Project:
Goodyear Total Tyres
Warehouse Facility
Site Address:
LOT 205 on SP2955994

LANDSCAPE PLANS APPROVED

Application No.: **OPW/2022/1618**

Landscape Operational Works SPECIFICATION & PLANTING SCHEDULE

Scale:	
Designed:	JLS
Checked:	JLS / MG
Approved:	
Date:	06.12.22
Drawing No:	6098-L-PRI-SP01
Rev. No:	D

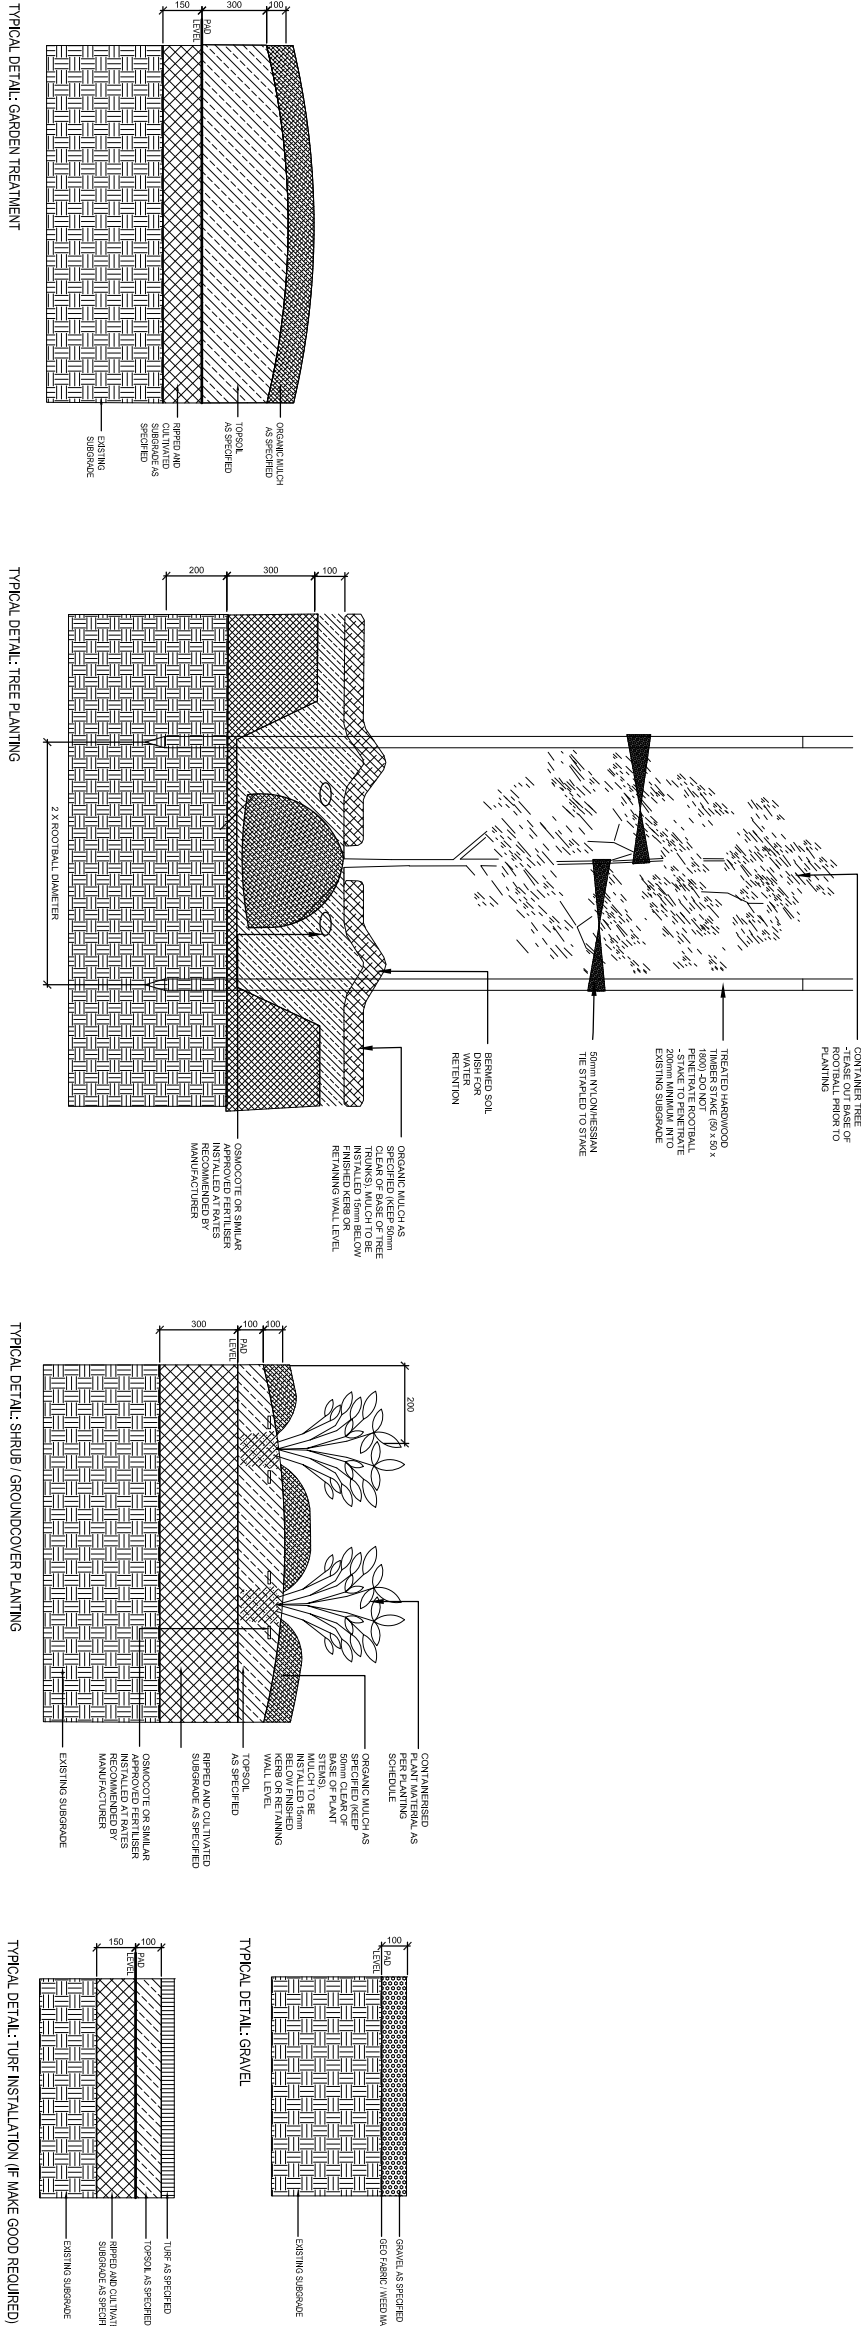
- All under sized or poor quality stock will be required to be replaced prior to inspection approval.
- Existing Street trees must be staked, mulched and edged as per City Plan - Street Tree Planting - Set-out guidelines Tree planting plan. Damaged street trees must be replaced with minimum 100 litre stock.
- All road reserve turf must be repaired or replaced if damaged.
- All trees must be staked, edged and mulched.
- Plants damaged in construction must be replaced with the same species at the same size. All planting to be within an edged and mulched garden bed complying with the City Plan Policy - Landscape work.
- All nursery bamboo stakes and plastic/rubber ties must be removed from planted tree specimens before final inspection.

Replace Crinum pedunculatum with Hymenocallis speciosa due regular decimation by Lilly caterpillar.

Substitute 32 x WESTFR with 15 x SYZaus

Landscape Operational Works
DETAIL DRAWINGS

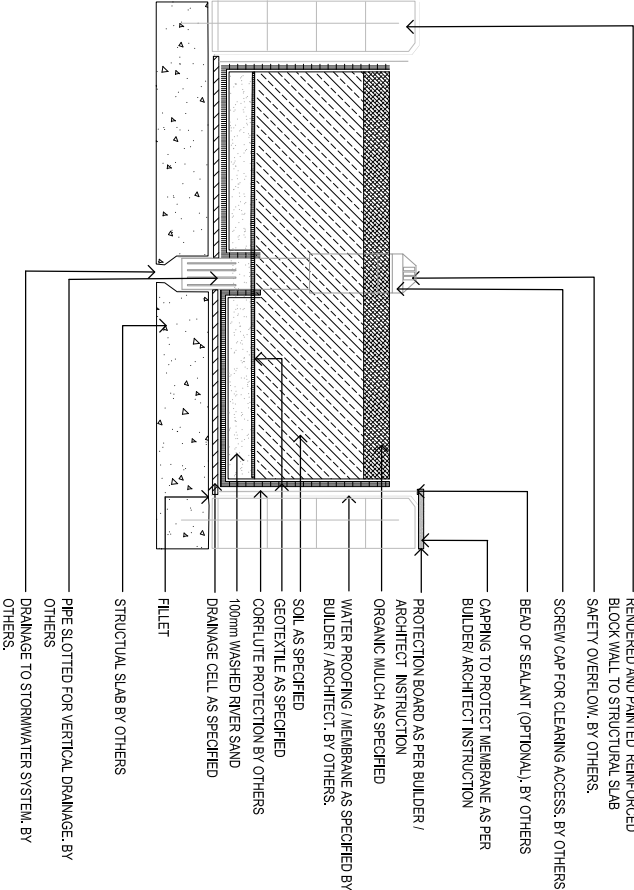
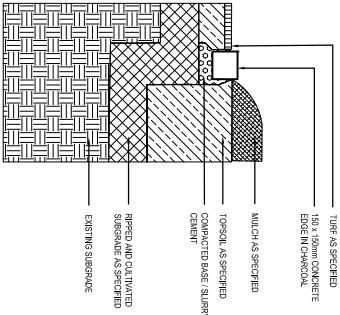
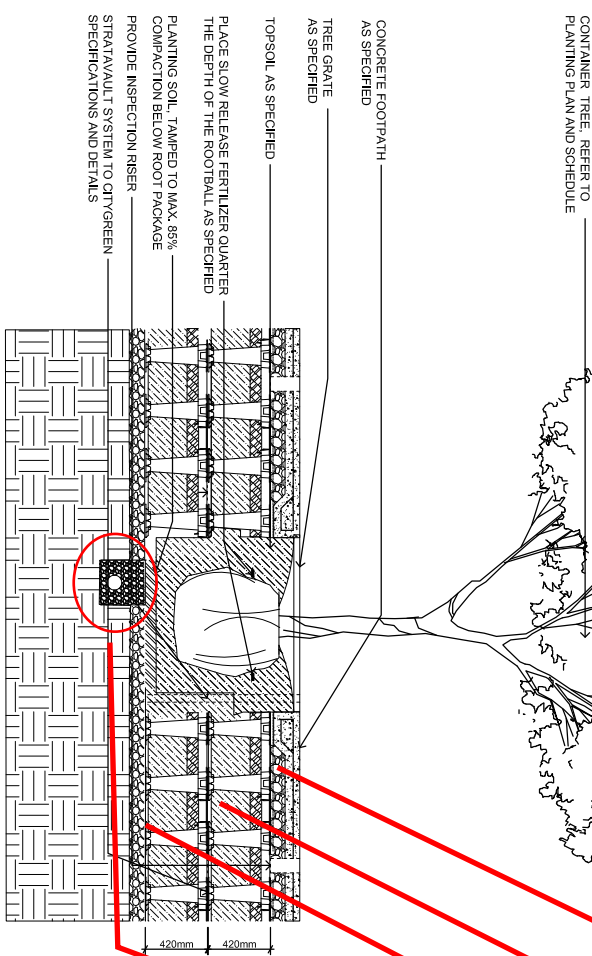
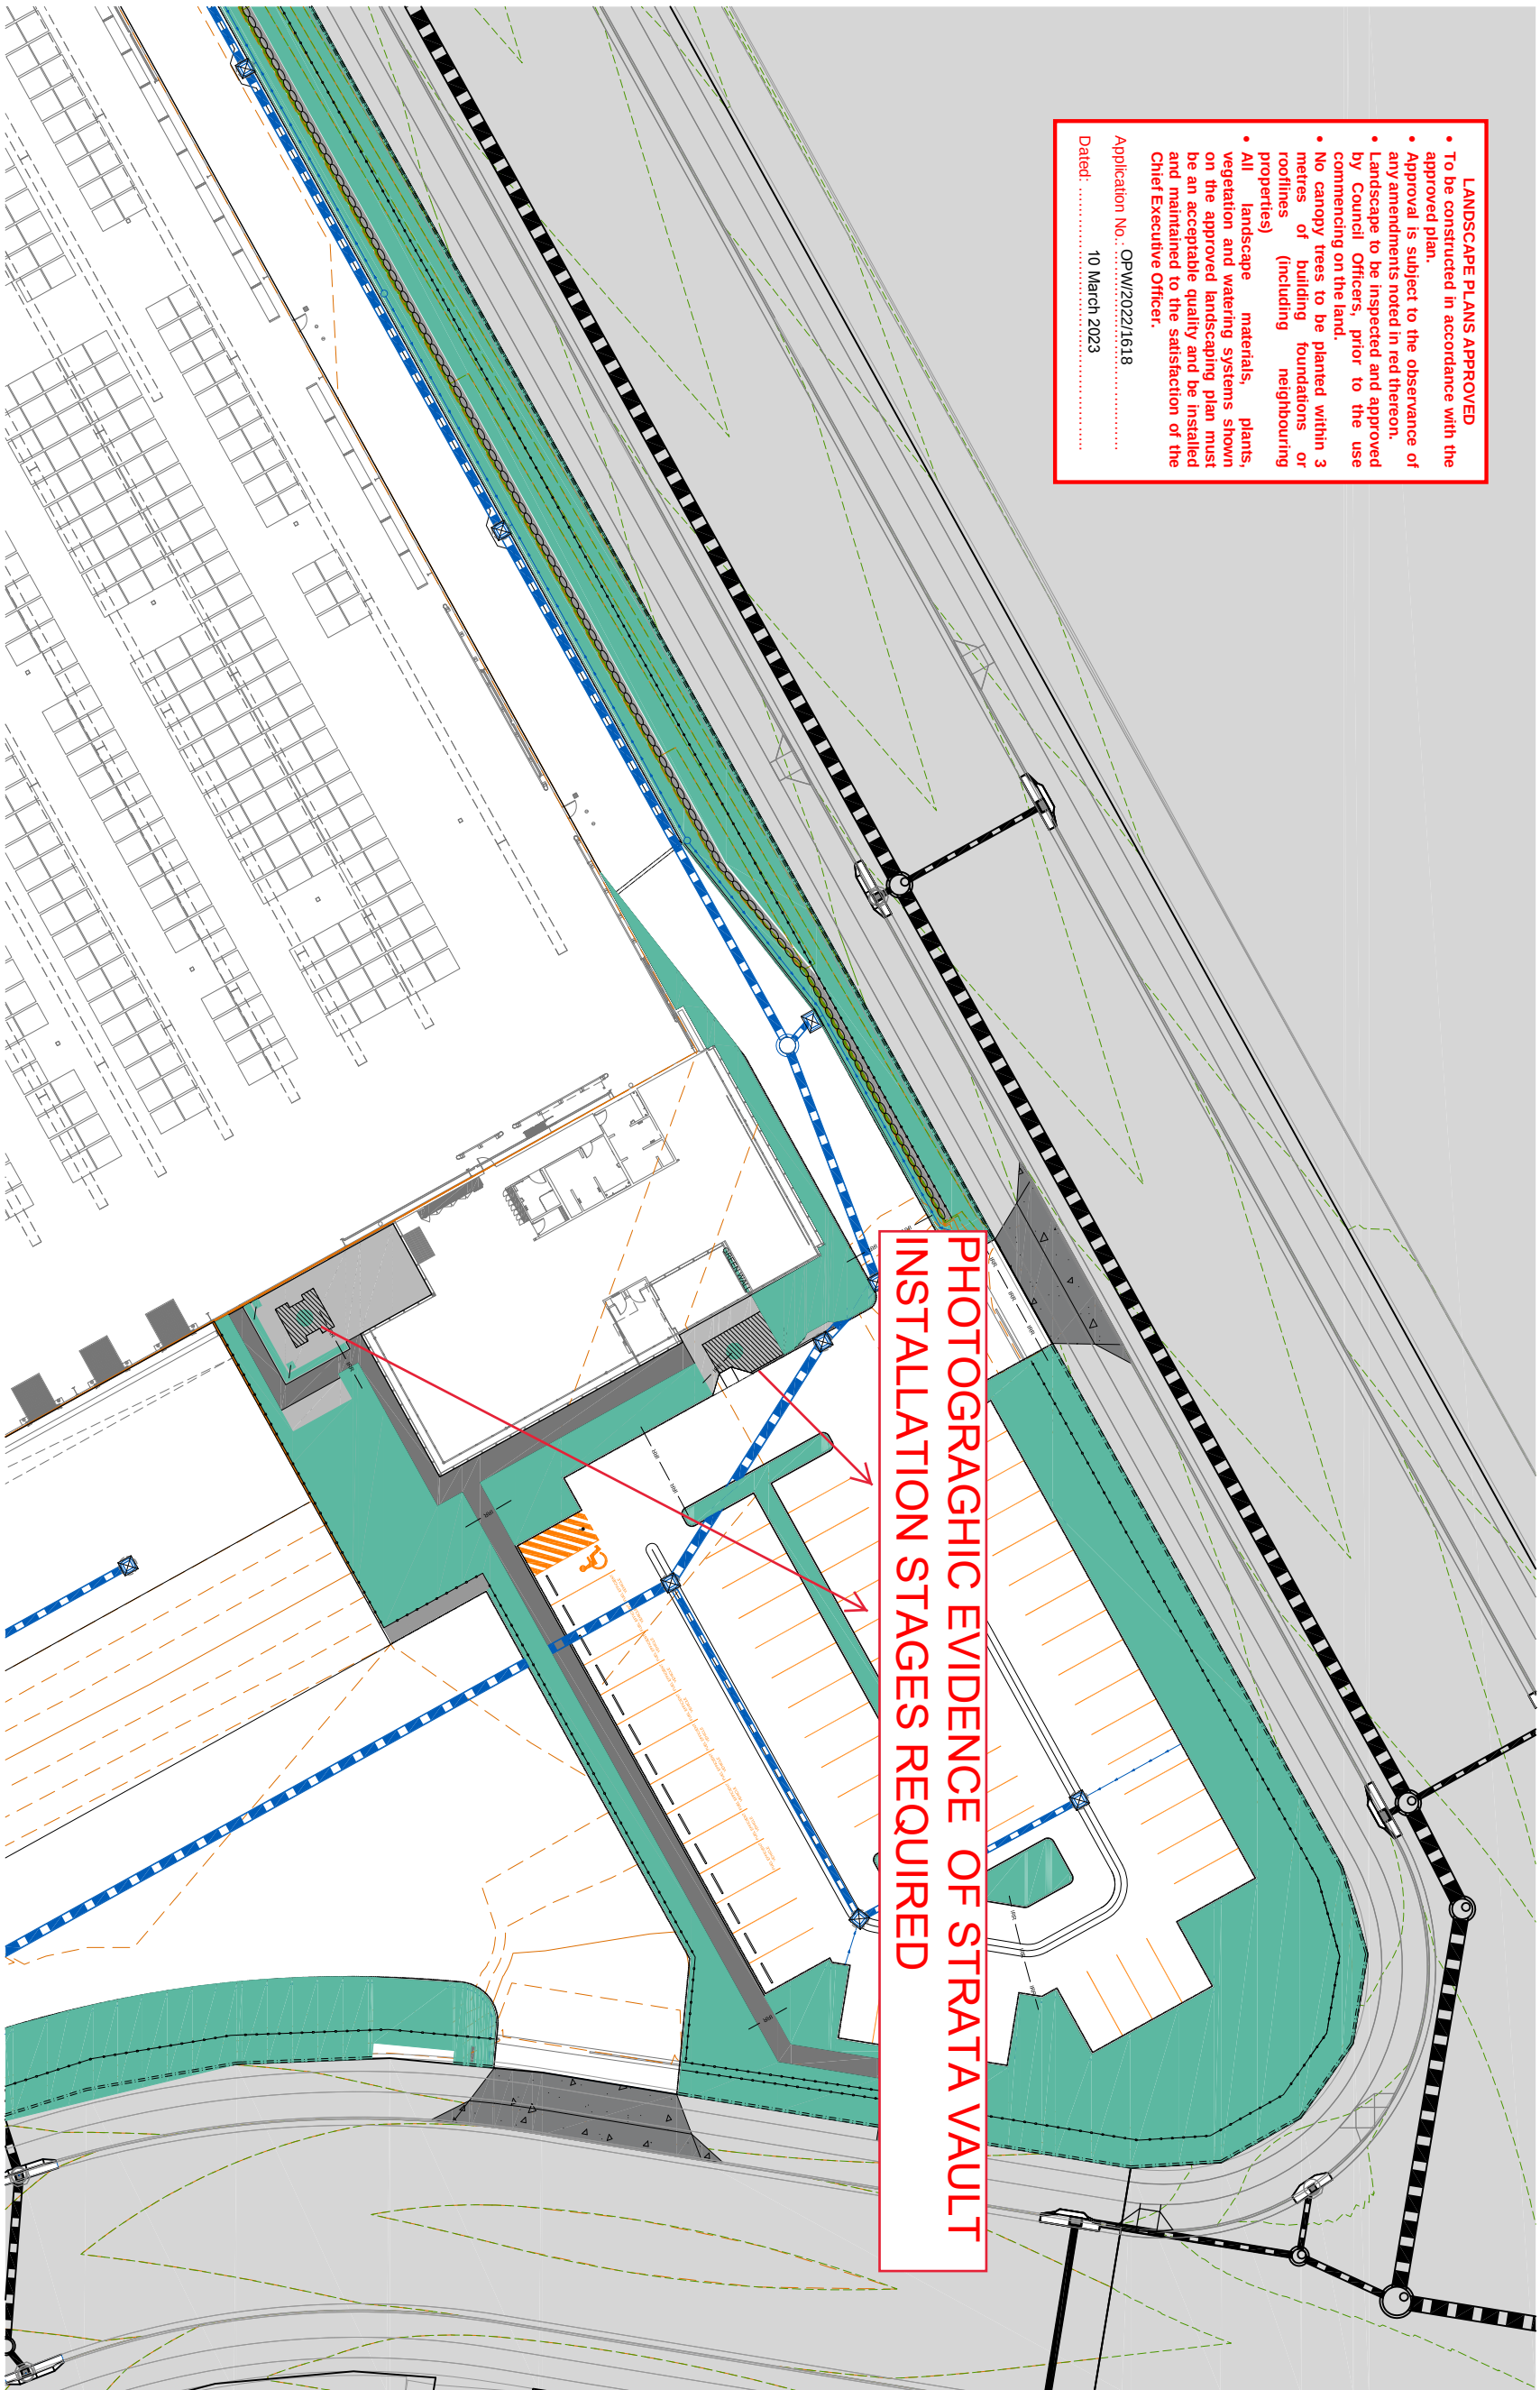
PHOTOGRAPHIC EVIDENCE OF STRATA VAULT INSTALLATION STAGES REQUIRED

PHOTOGRAPHIC EVIDENCE OF STRATA VAULT
INSTALLATION STAGES REQUIRED

Drawing No: 6098-L-PRJ-ST05 Rev. No: D

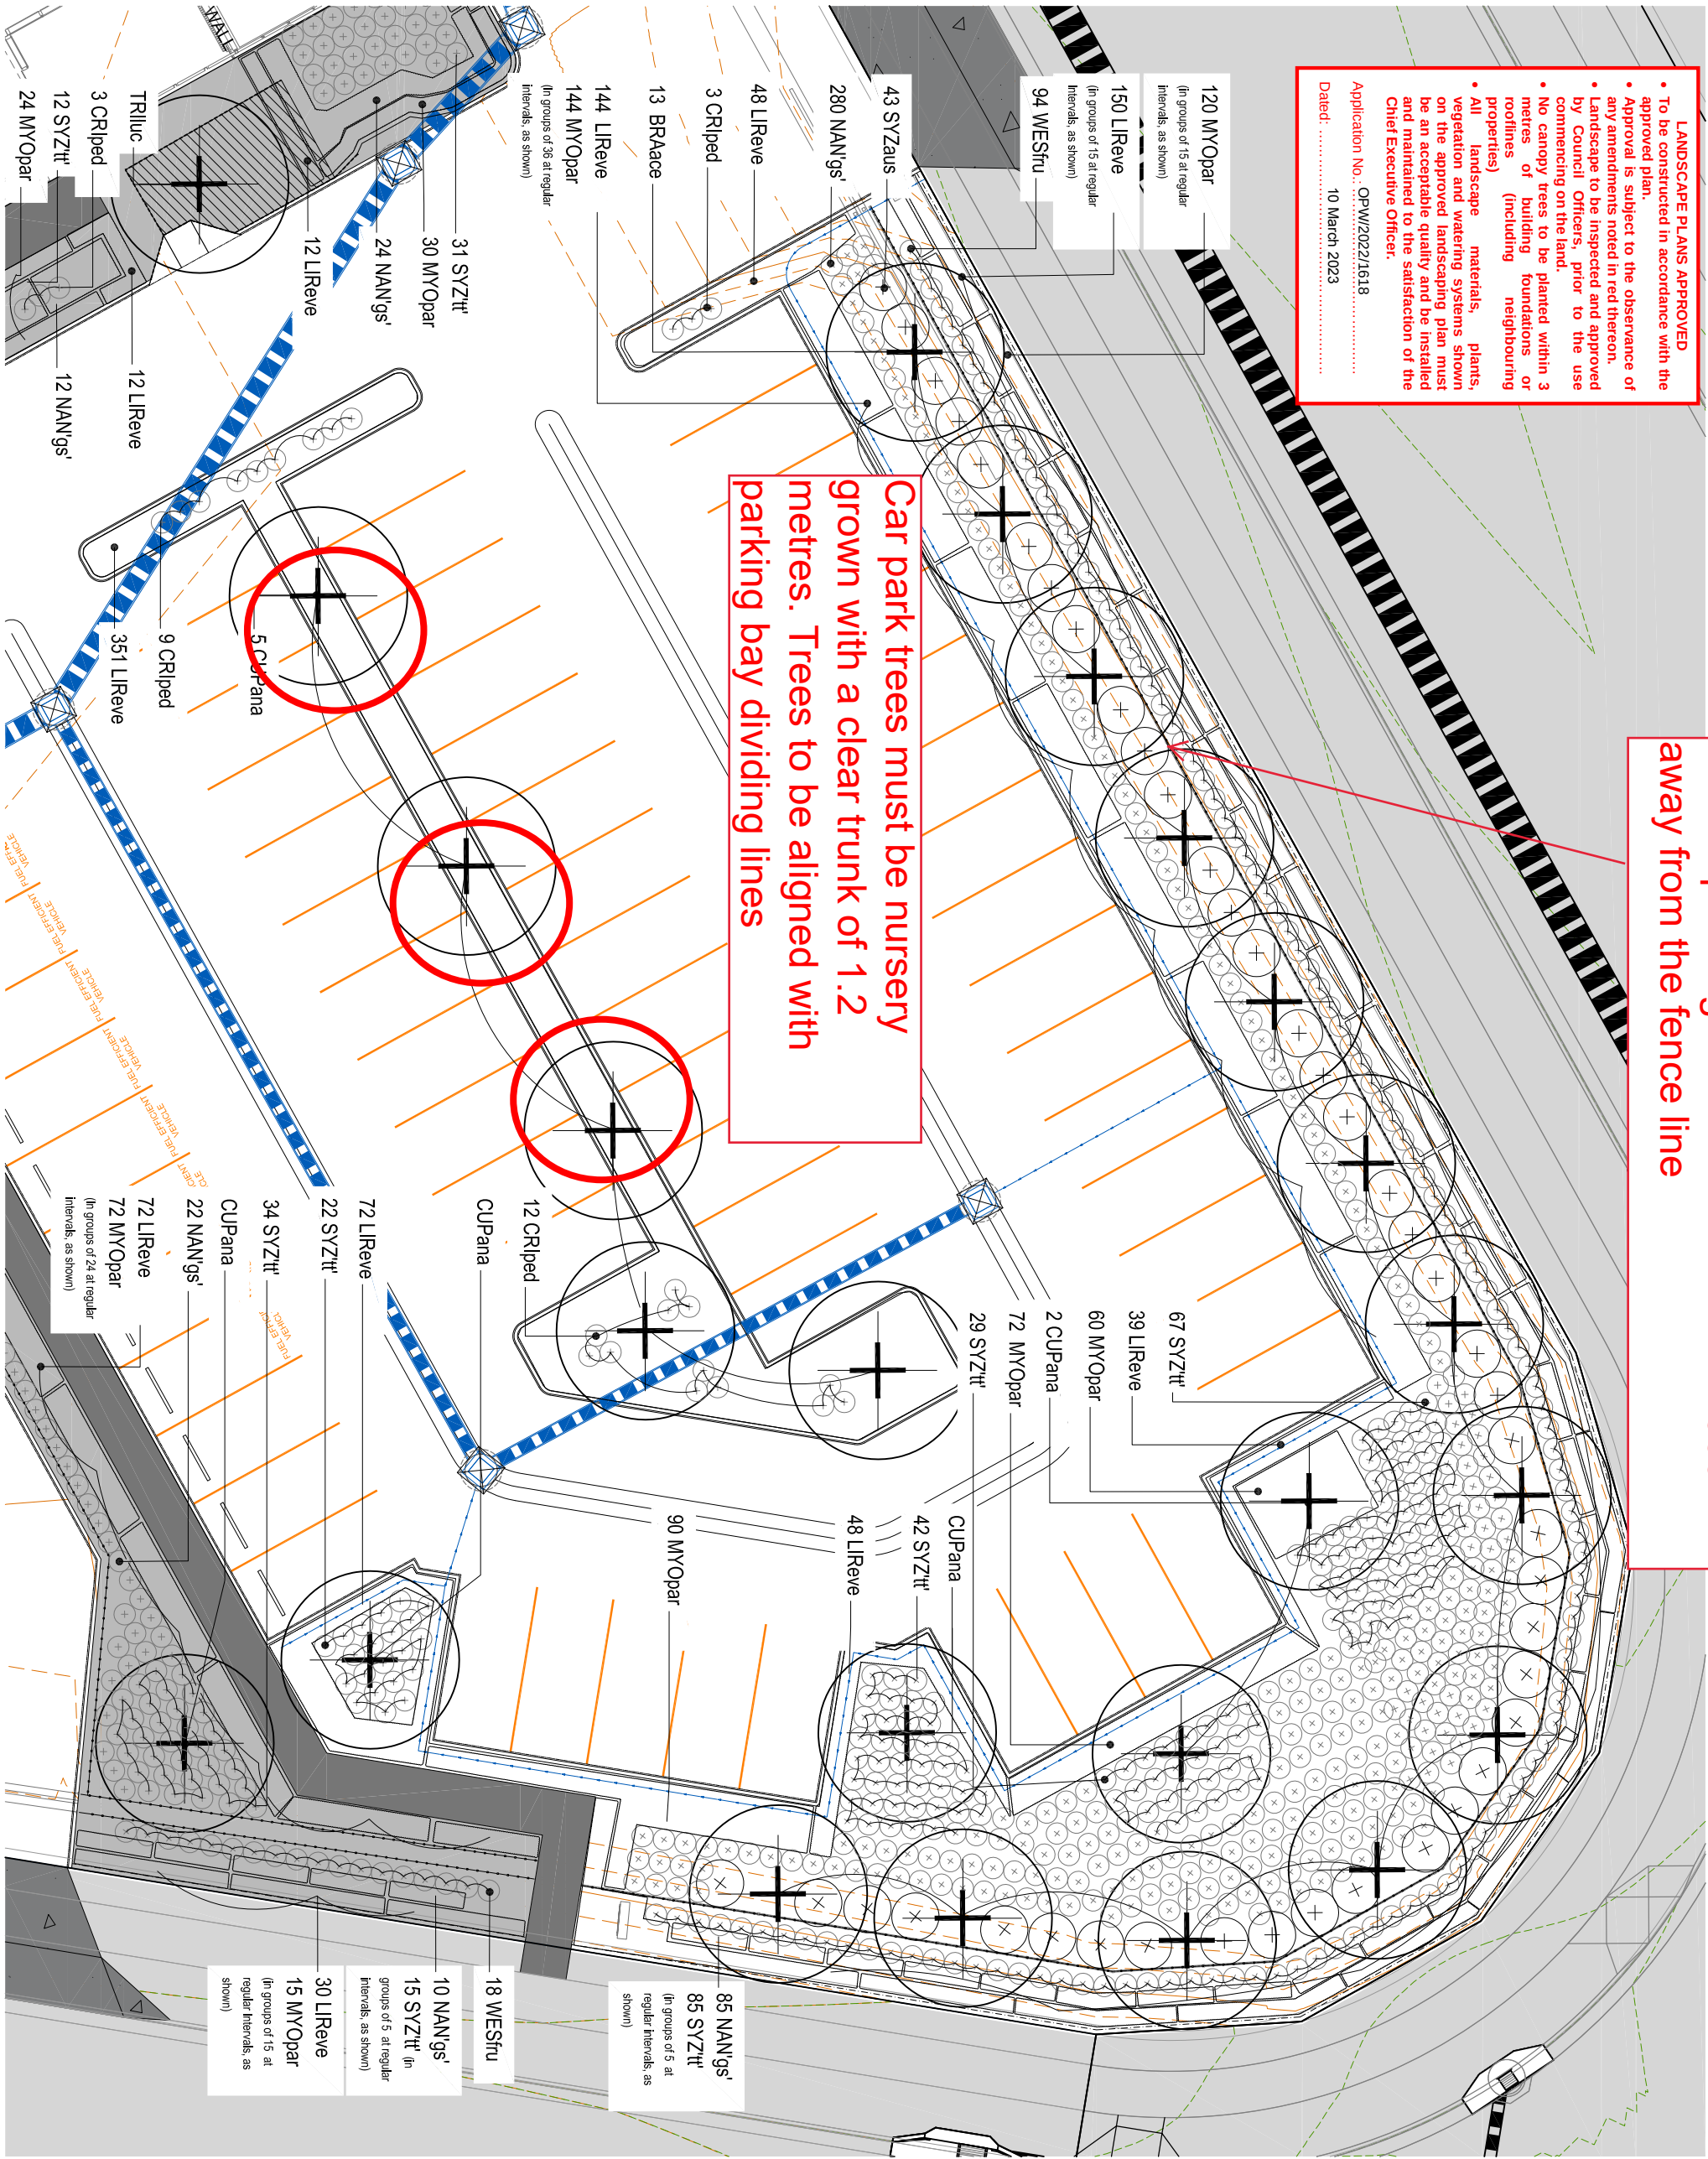
All tree planting must be a minimum 1000mm away from the fence line

Car park trees must be nursery grown with a clear trunk of 1.2 metres. Trees to be aligned with parking bay dividing lines
